Review Date: OCTOBER 31, 1985

Report Date: JANUARY 1986

ENVIRONMENTAL REVIEW TEAM REPORT
ON
A PROPOSED RESEARCH/EXECUTIVE PARK
OLD SAYBROOK, CONNECTICUT

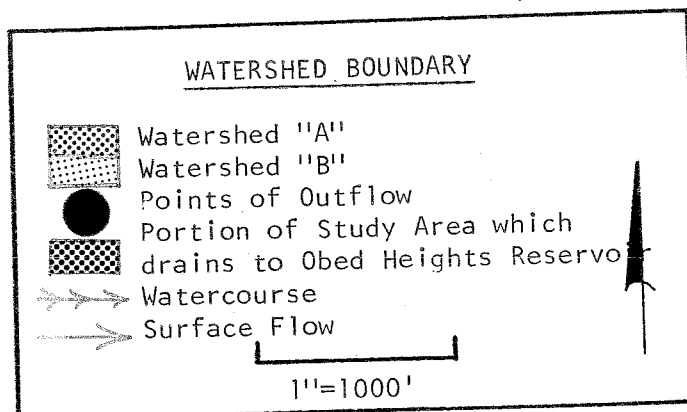
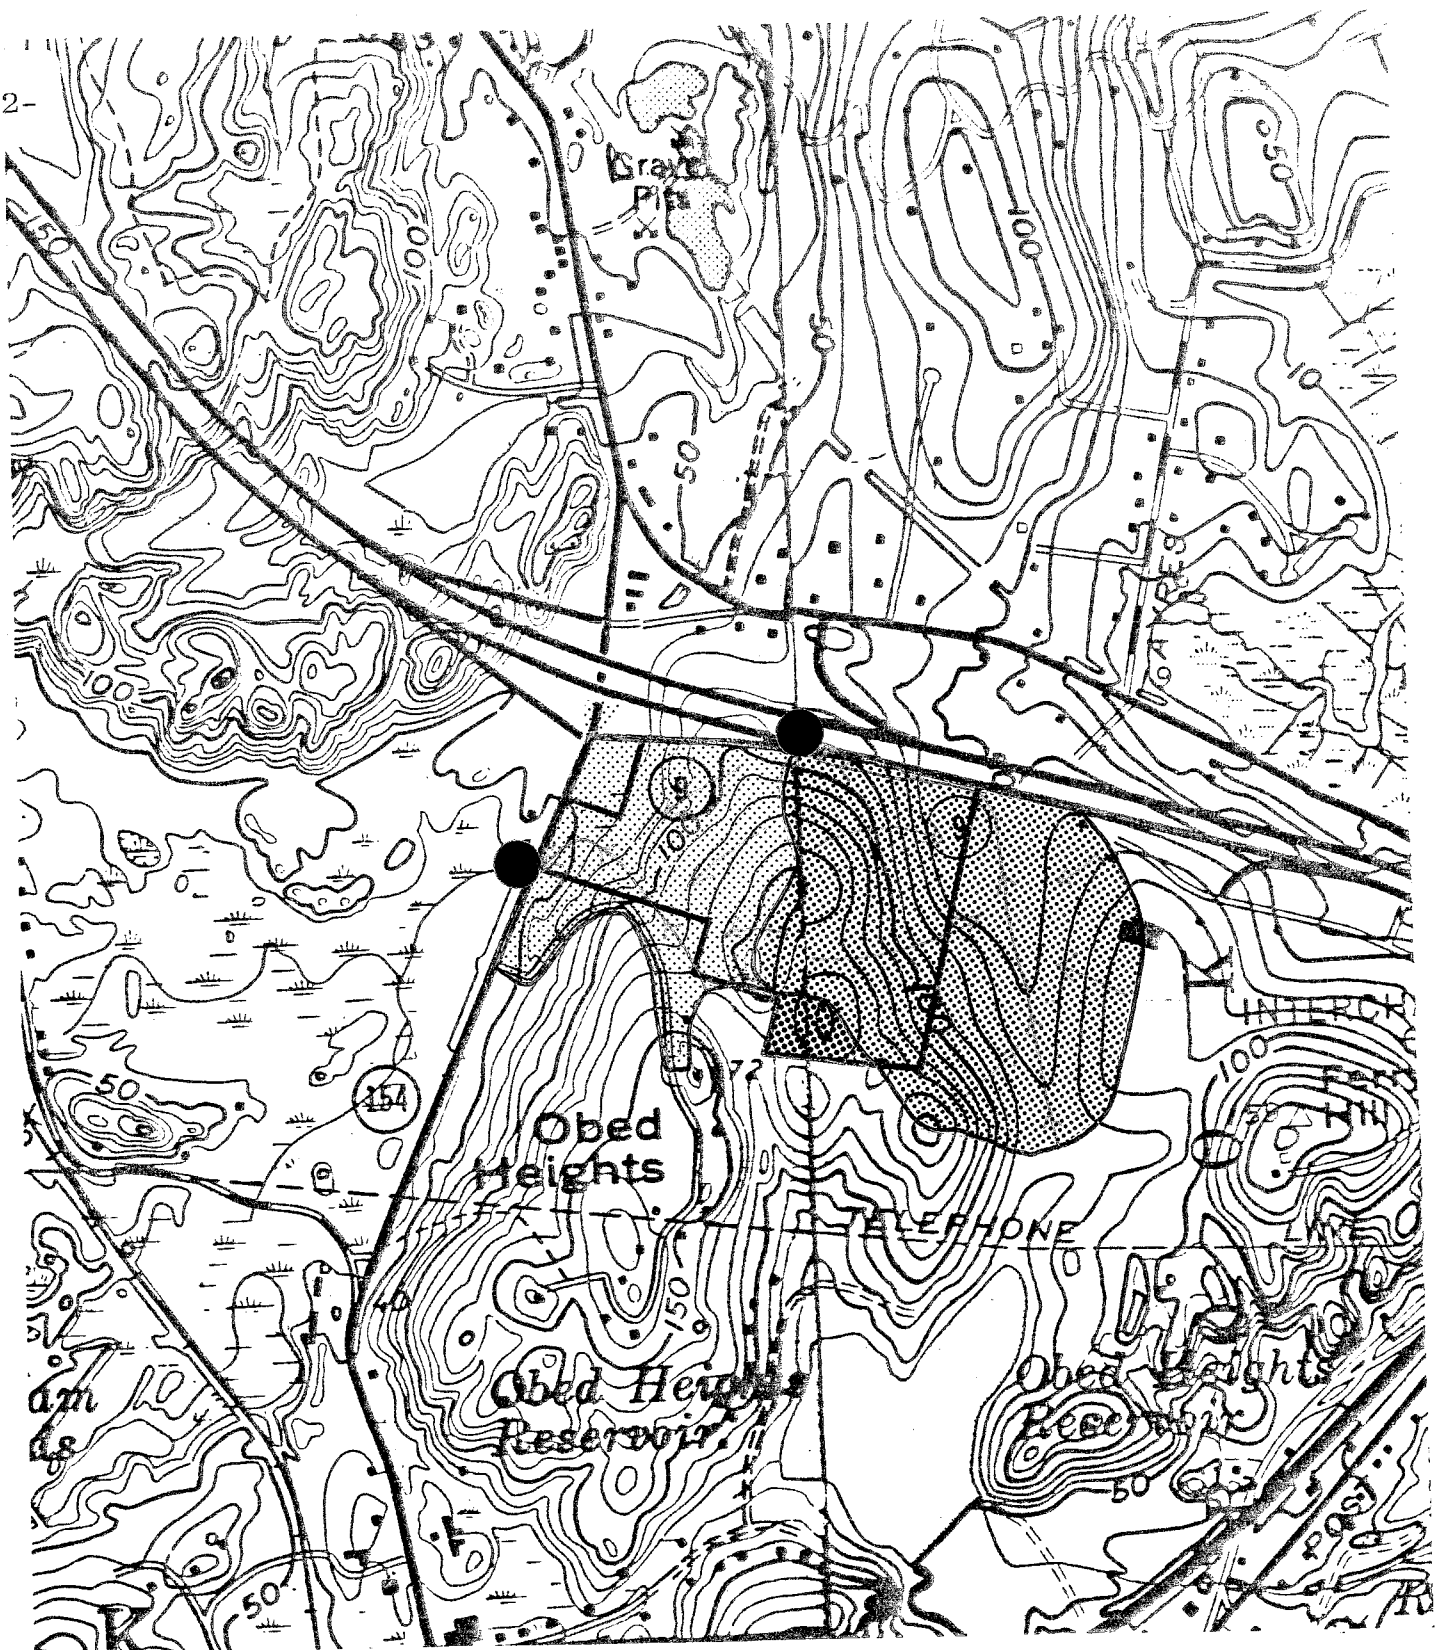
Surface runoff on the site may be divided into three areas. Surface runoff generated in western half of the study area drains to the low-lying areas in the western limits. It then flows southward parallel to Route 154 for about 375 feet where it is routed through a 12 inch pipe under Route 154. This unnamed watercourse is a tributary to Oyster River. Surface water generated in the eastern parts flows downslope to a low-lying area which contains a small intermittent stream. It should be pointed out that a relatively large pond is being built in this low-lying area. The intermittent stream flows northward to Route 9, then makes a 90° turn to the west and flows parallel to Route 9. The stream is then routed northward through a four foot culvert beneath Route 9. It ultimately drains into an estuary of the Connecticut River.

A small ± 3 acre portion of the study area in the southern part drains southward to Obed Heights Reservoir. Accompanying this report is a Watershed Boundary Map which shows the watershed boundary, direction surface runoff, and streamcourses on the parcels as discussed above.

Development of the parcels in question can be expected to lead to increases in stormwater runoff. The amount of increased runoff will depend largely on the density of the proposed research/executive park, extent of development, amount of vegetation removed, the amount of impervious surface created (e.g., roof tops, paved roads, parking areas) and the timing of development on each lot. Since large parking facilities and buildings may be associated with this type of development, the potential for a significant increase in runoff is greater than would be the case for a low intensity single family home development.

Because these increases are significant, especially watershed 'B', it is strongly recommended that a detailed engineering study of the pre and post development runoff for the parcels, as well as a careful stormwater management plan, be prepared prior to any development. In addition, close examination of all downstream culverts should be required to insure that flooding problems do not occur. Of particular concern, will be the 12 inch pipe passing under Route 154, which would receive runoff from watershed 'B'. As mentioned earlier, the potential for significant increase in the runoff depth from this watershed following any development could pose flooding problems in this area. In this regard, it may be necessary to investigate the possibility of developing a detention basin for controlling post development increases in runoff or possibly to increase the size of the pipe running under Route 154.
